## Water Resources Department

1. Workman's Airpark Water Association, Inc. (start card number 111453)

#### REQUEST FOR WRITTEN APPROVAL TO USE CONSTRUCTION METHODS NOT INCLUDED IN OREGON ADMINISTRATIVE RULES 690-200 THROUGH 690-240

(7) Diagram showing the pertinent features of the proposed well design and construction (attach additional pages if needed):

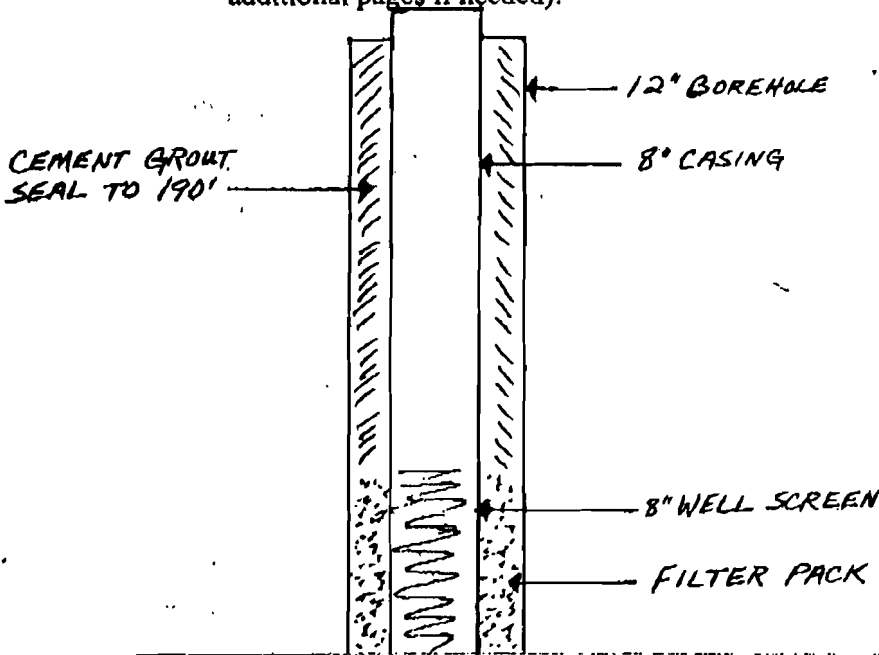
(4) The distance to the nearest well, septic tank or drainfield (if water supply well): 86 FT.

(5) The unusual conditions which necessitate this request: SMALL LOT SIZES DON'T  
ALLOW THE NORMAL REQUIRED 100' SET BACK. (SEE ENCLOSED SITE MAP)

(6) The proposed construction methods that the well constructor believes will be adequate for this well (attach additional pages if needed)  
A CONTINUOUS GROUT SEAL TO 190'. THIS IS A REQUIREMENT OF THE  
WATER RIGHT PERMIT. #G-12872

I have also discussed this issue with a representative of the Oregon Health Division and they concur that the special standard will provide adequate additional protection to the water bearing zone.

Date: 8-12-98

Approved by: [Signature] Denied by: \_\_\_\_\_
